ZONING PLAN
Spring Hill Parkway Tract

PETITION NO: Z-24

Z-24

ZONING COMMENTS:

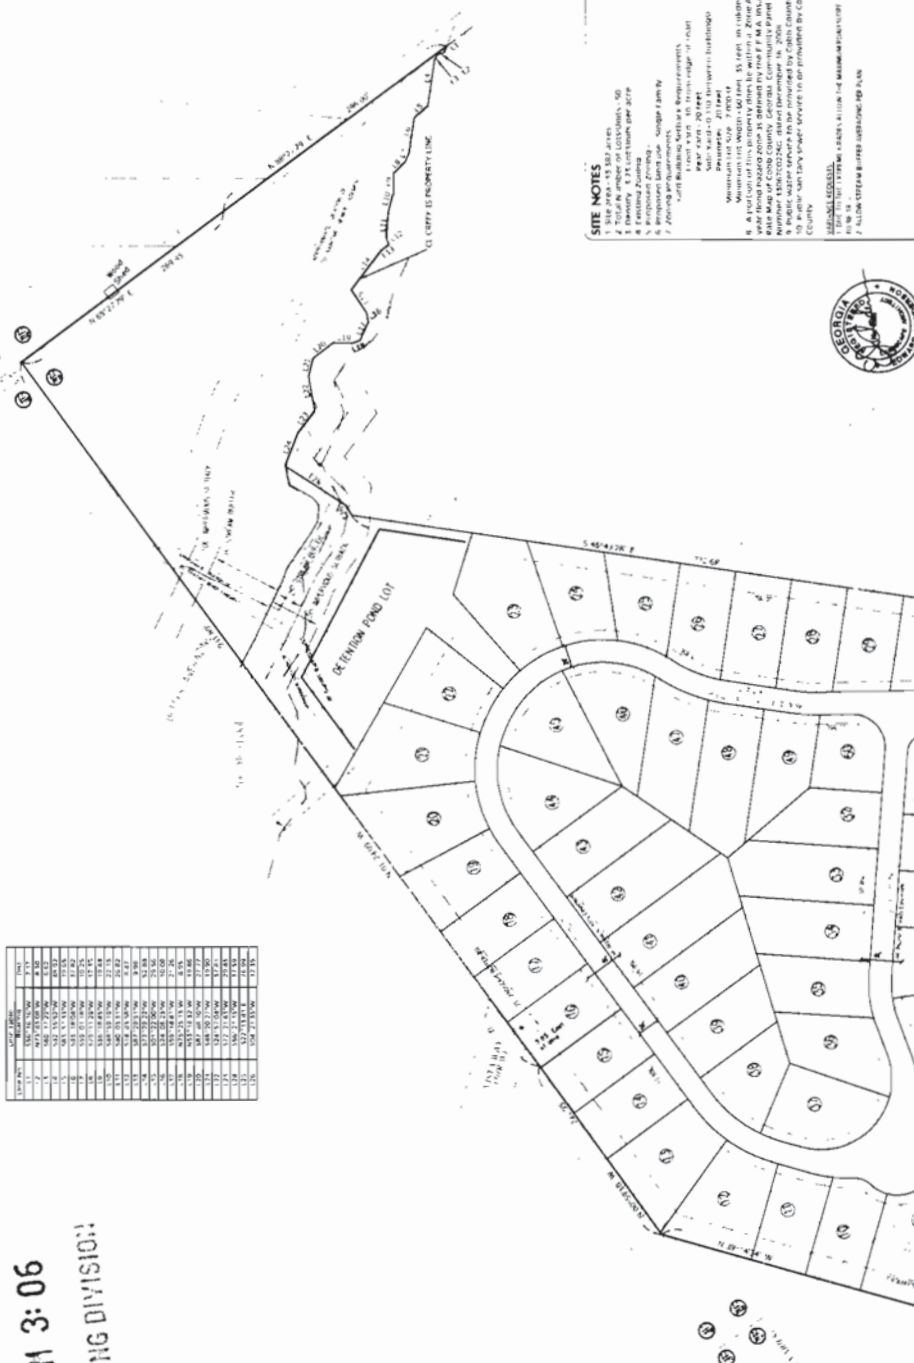
When projects contemplate less than 20 foot separation between units, guest parking shall be provided or the streets shall be labeled as a fire lane.

1. This parcel is located on very steep terrain. The average slope for the majority of the site is approximately 25% with some areas exceeding 30%. The proposed small lots with narrow widths will require significant grading. Adequate erosion control will be difficult to maintain. Elevated erosion and sediment control measures will be required.

2. While the general location of the detention facility is appropriate, the proposed configuration will require a stream buffer variance. The northwest corner of the pond conflicts with the existing sanitary sewer. Either the detention pond or the sanitary sewer must be relocated.

3. Private streets are proposed. This will require the infrastructure (water, sewer and storm drainage systems) to be private as well. Provision for perpetual maintenance of these systems must be provided for in the HOA covenants.

4. Drainage easements and adequate swales will be required at the rear of the lots along the western and eastern site boundary to control offsite runoff bypass.

Recommend a deceleration lane on Spring Hill Parkway for the entrance.
